## Official Recall Notification Under the U.S. Federal Boat Safety Act

# Replacement of the Core Wire of the Intermediate Shift Cable on Mercury MerCruiser Alpha and Bravo Sterndrives

Revised May 2012. This bulletin supersedes the previous bulletin number 2010-11R1 August 2010.

**Green or blue dot on the end of the core wire indicates a corrected core wire**

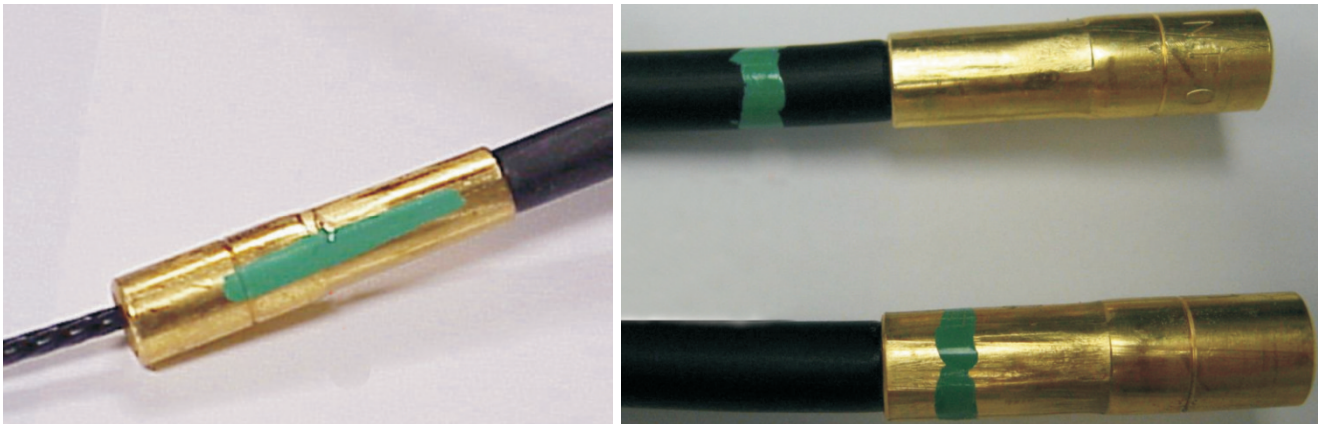
Cables in transoms within the affected serial number range or cables within the date codes have been repaired if they are marked with a green or blue paint dot on the cable end. Corrected cables are now being marked with a green paint stripe on the barrel of the cable jacket or a stripe of green tape around the outside of the cable housing at the engine end of the cable. If this green marking is present, core wire replacement is not necessary. Some cables did not receive the paint mark on the outer cable. If the paint dot is present on the core wire end but not on the outer cable, the cable is still good. Add a mark to the outer cable and submit a claim for inspection without replacement.

**Various markings to indicate a corrected cable**

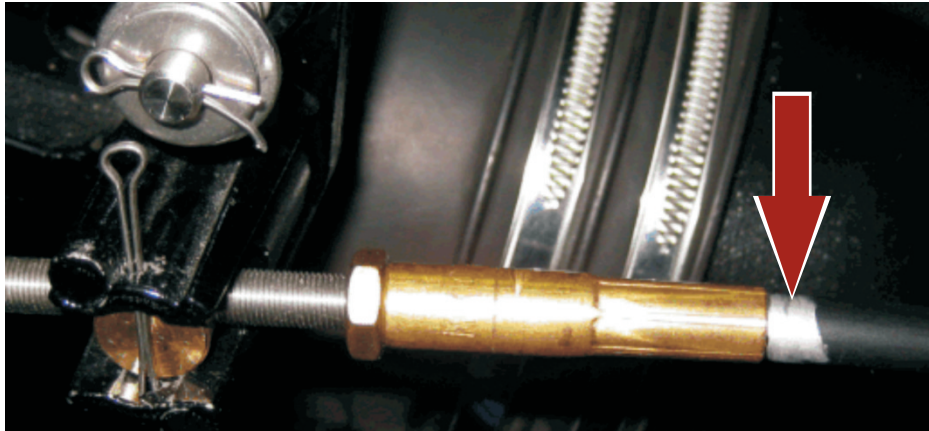
Corrected cables have been marked on the outer housing at the engine end to signify that the inner core wire has been changed.

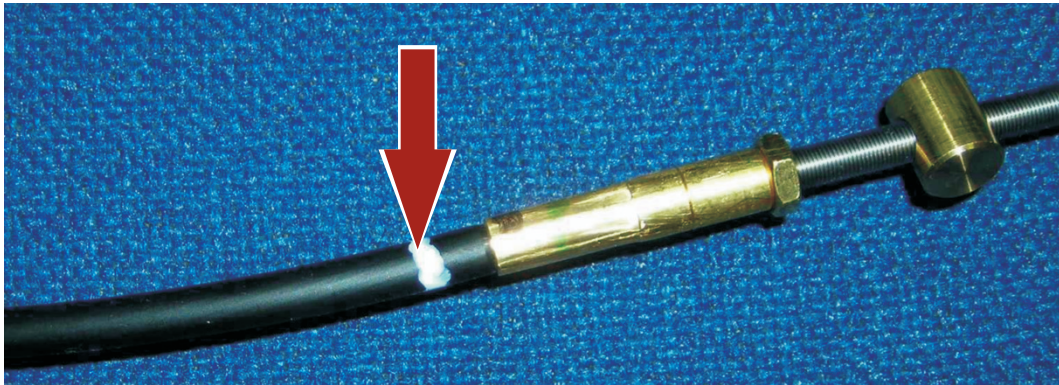
Boat builders have been painting a silver stripe around the cable behind the brass ferrule at the engine end of the cable to signify that the inner core wire has been changed. Regardless of the color used on the outer cable housing, the inner core wire is identified with a green or blue paint dot on the end.

**Dealers:** Mark the outer cable at the engine end as shown with a white paint line.
